Midway City Council
16 July 2019
Regular Meeting

Saddle Creek Ranch, Phase 1 /
Preliminary Approval

CITY COUNCIL MEETING STAFF REPORT

Subject: Saddle Creek – Phase 1 – Preliminary Review

WATKINS
 SADDLE CREEK - PHASE 1
 PRELIMINARY
 LANDSCAPE PLAN - PHASE 1

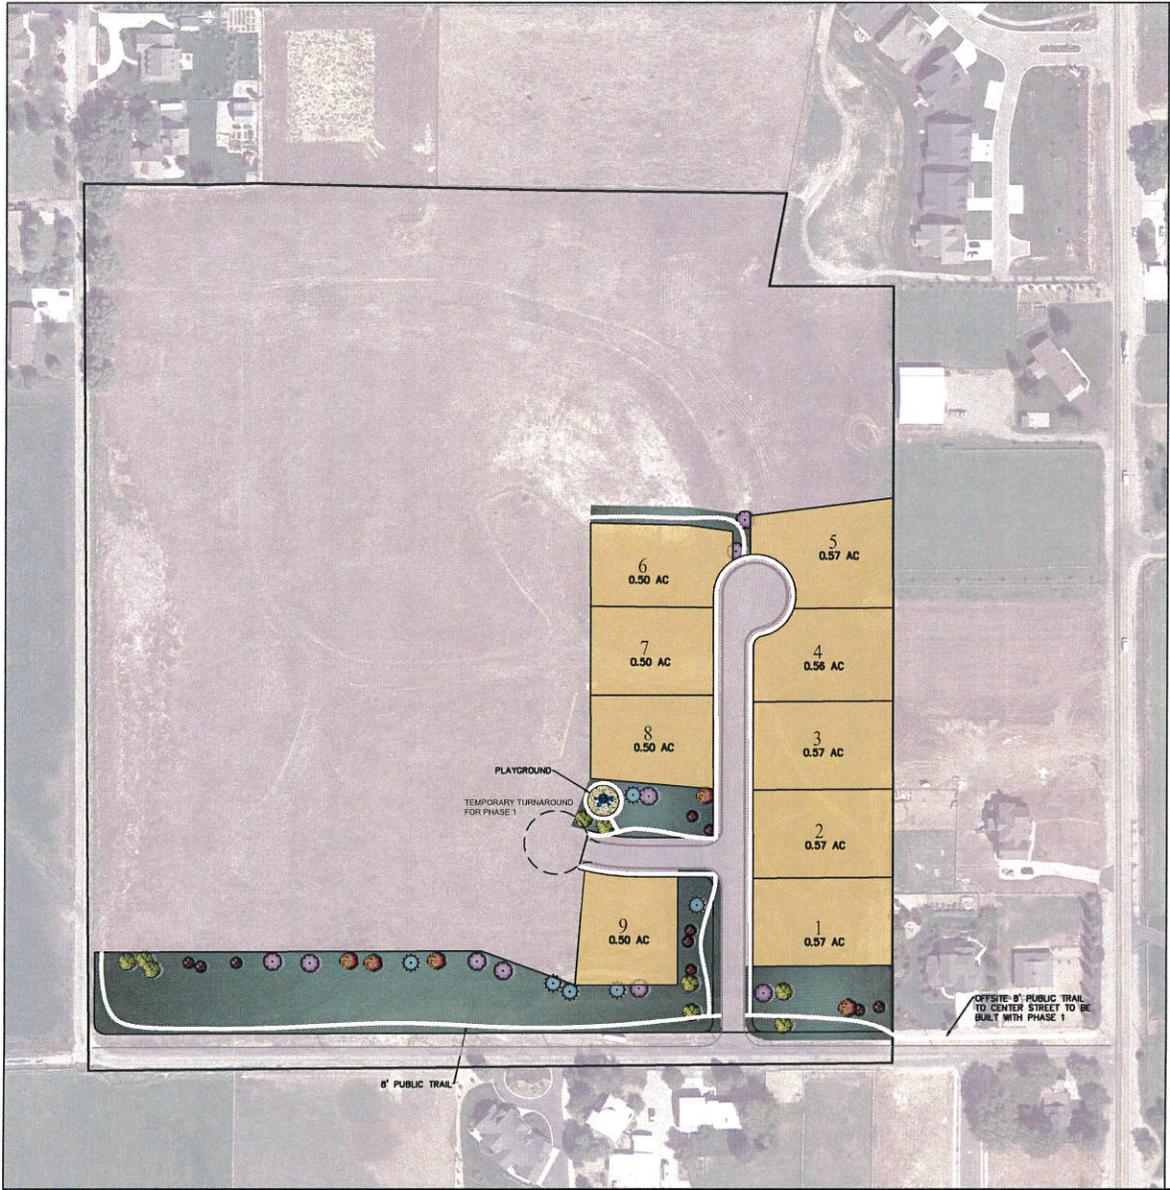
- The proposed landscaping cost shall be included within the improvements bond.
